TOWN OF NISKAYUNA
Planning Board and Zoning Commission
Agenda
April 11, 2022
7:00 PM

AGENDA STATEMENT

ITEM TITLE: DISCUSSION: 3713 State Street – Goodyear Tire Store – site plan application for placement of a 20' long x 8' wide storage container on the property

ITEM TITLE: DISCUSSION: 2341 Nott St. – St. James Plaza – site plan application for placement of a Chase Bank ATM in a portion of the Shop Rite parking lot.

SECTIONS & DETAILS

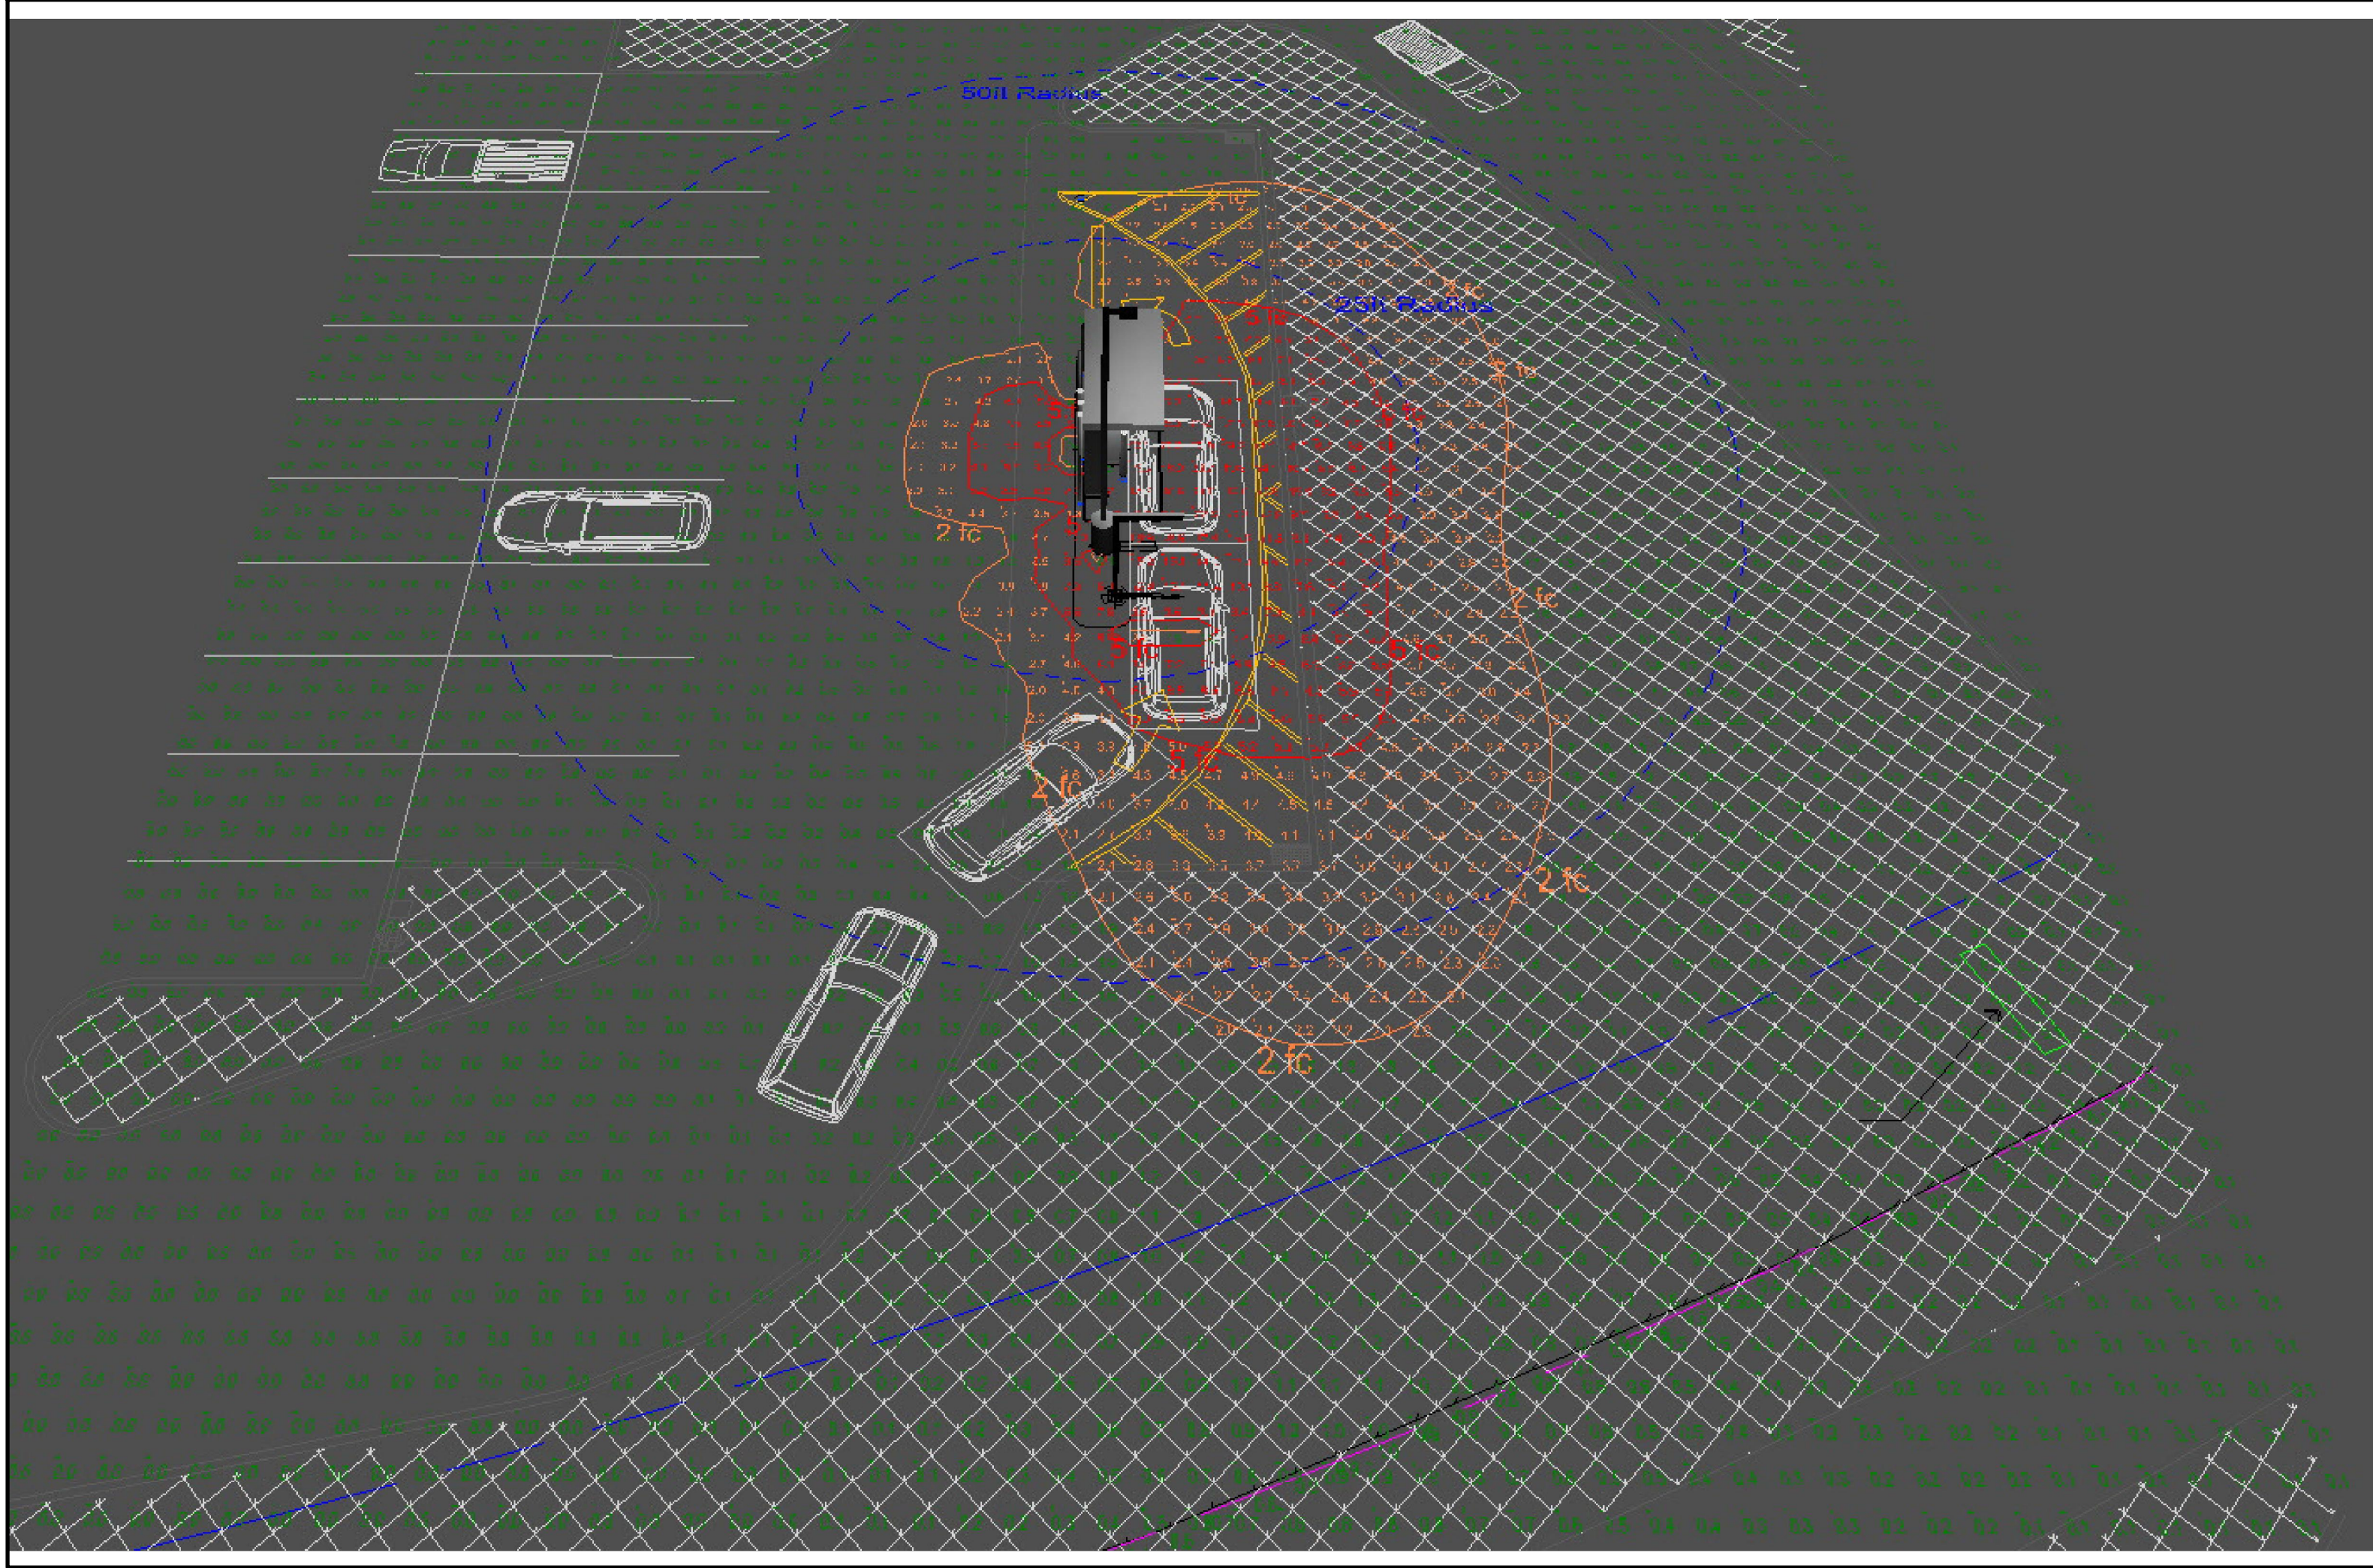
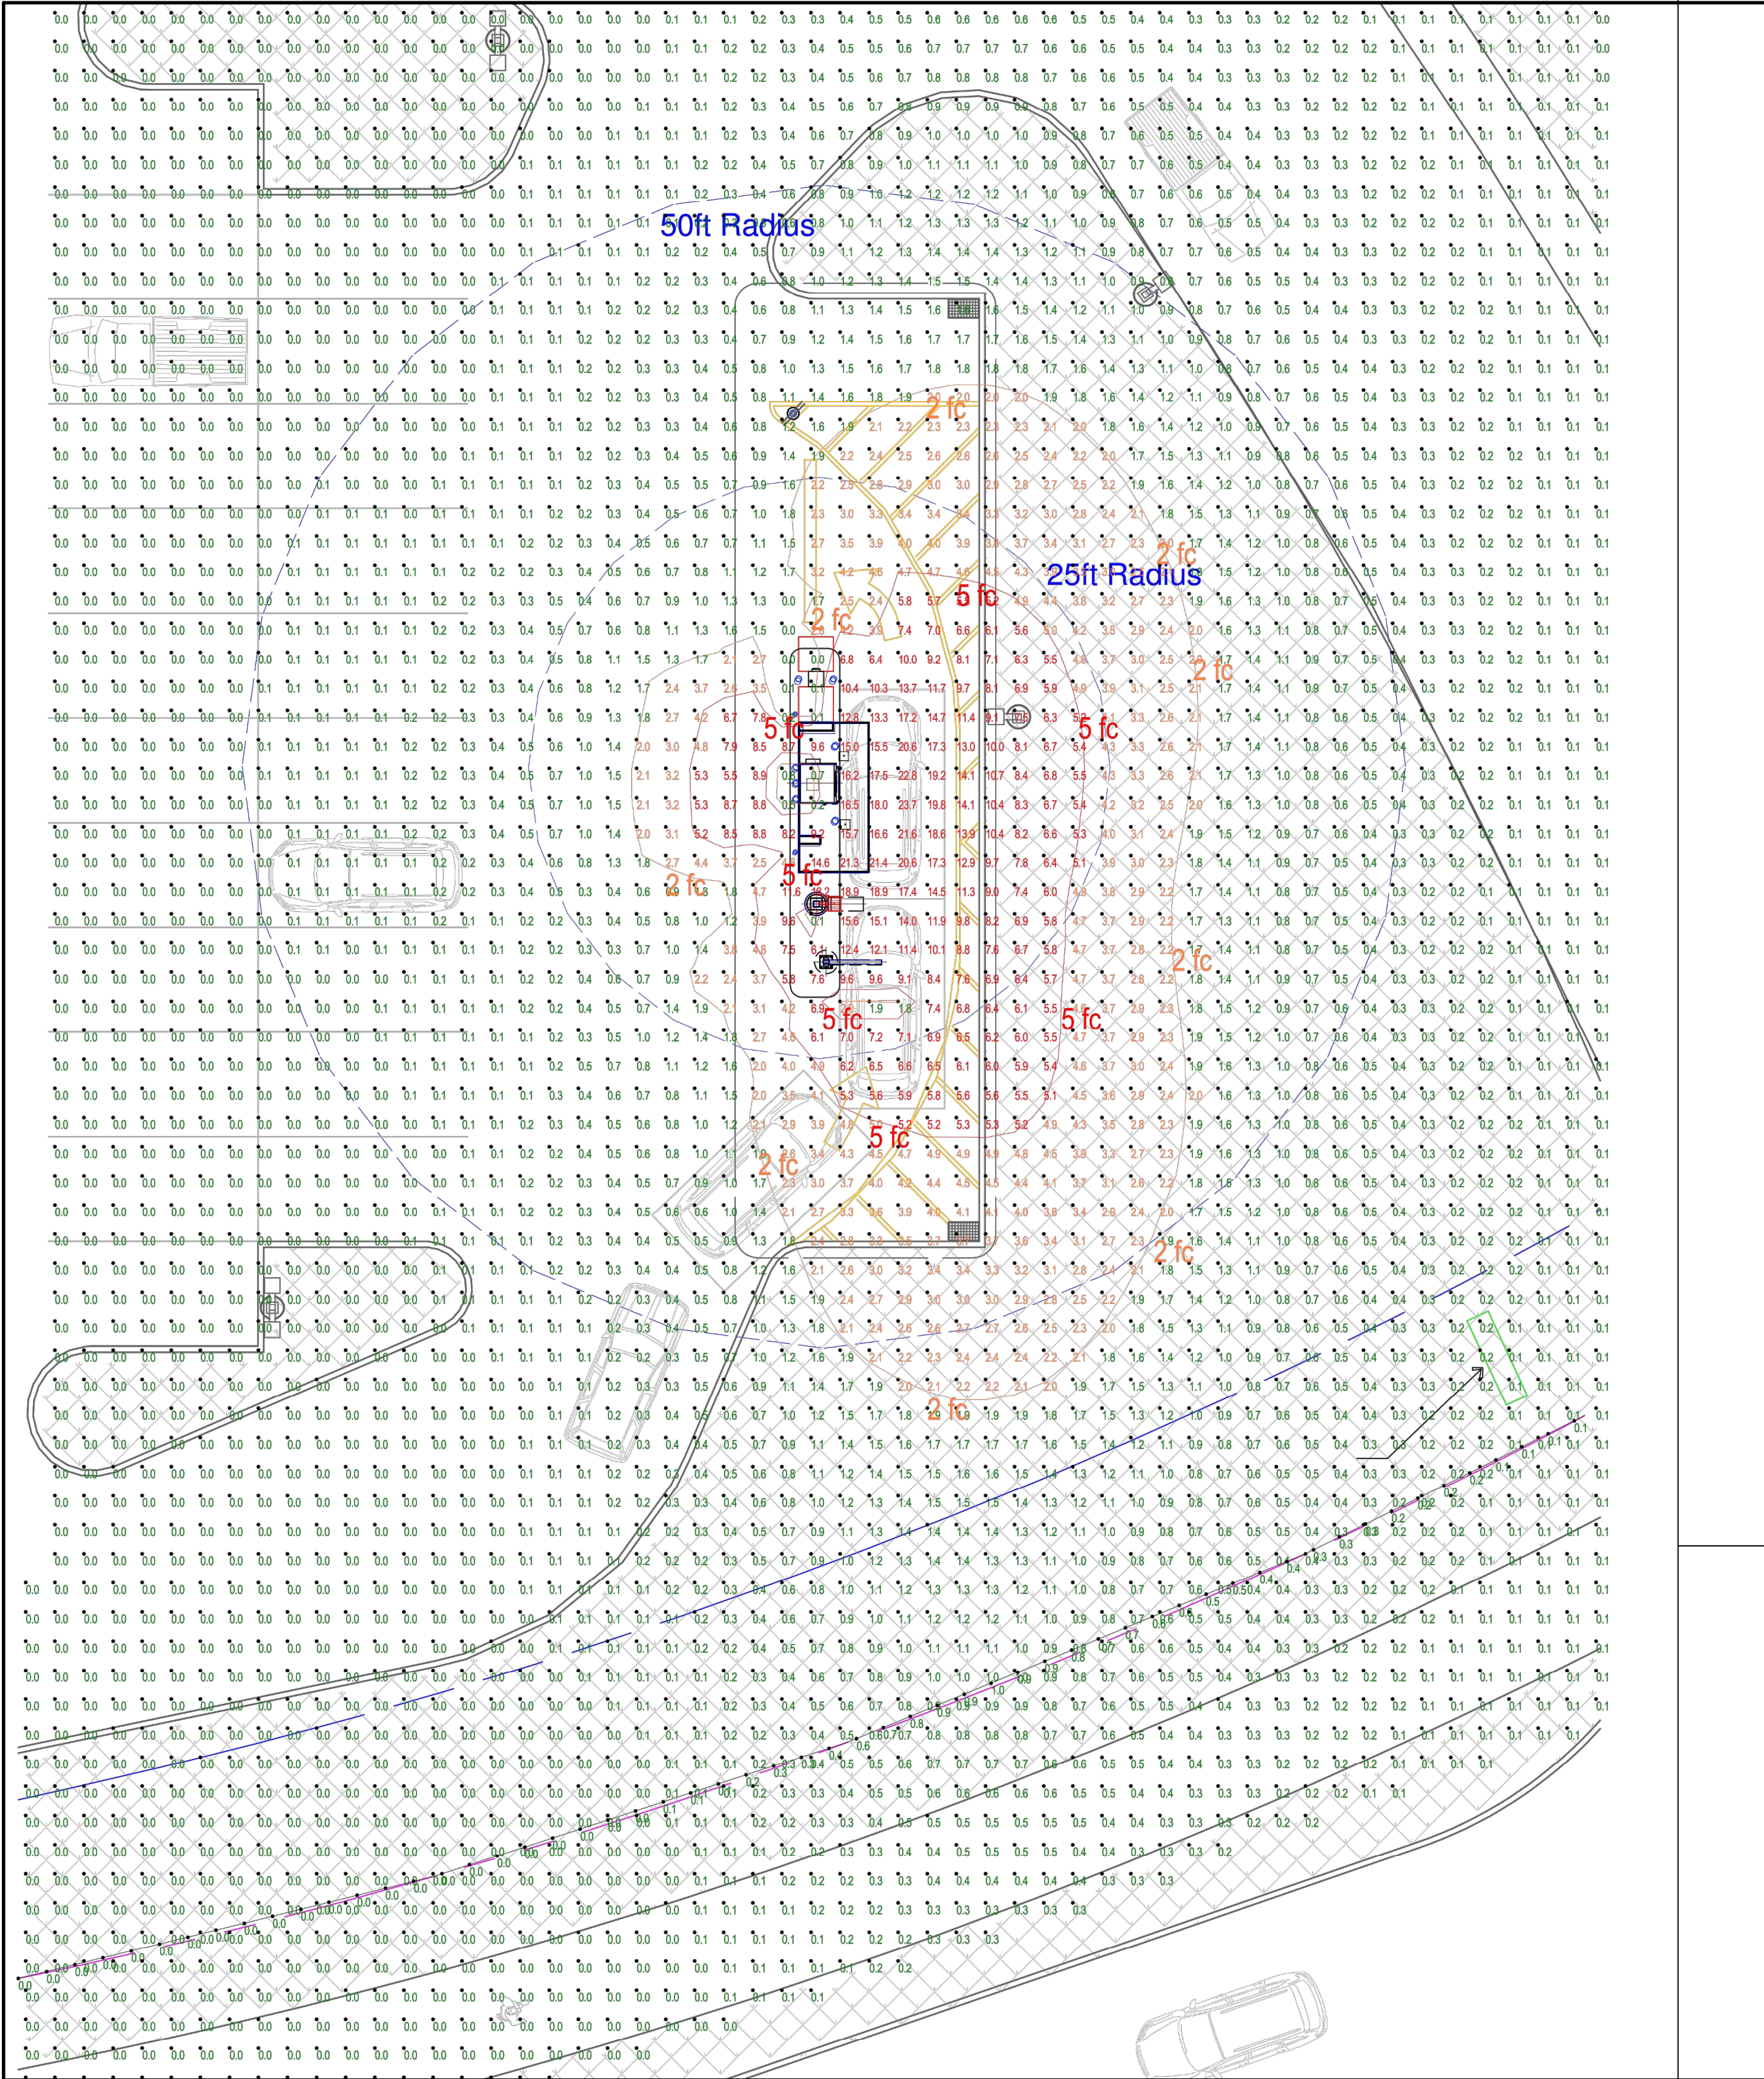
As proposed, page A104 of the drawing set includes a lighting fixture described as “Model ALED2T150N (Type II) 4000K LED 120-277V 151.4 Watts LED area light”. Therefore, a waiver for an LED light rather than a metal halide light is required.

Section 220-48.4 Signs E Minimum performance criteria (5) Logo states: "In the event that a picture logo is displayed on a sign, it shall be incorporated into the permitted sign area to comprise not more than 30% of the sign area". As proposed, the drawings show a two-sided "non-illuminated octagon signage option" located above the aluminum "signature canopy" that partially shields the ATM machine from weather. The logo comprises 100% of the sign area so a waiver for a sign with a logo covering 100% of the sign area may be required.
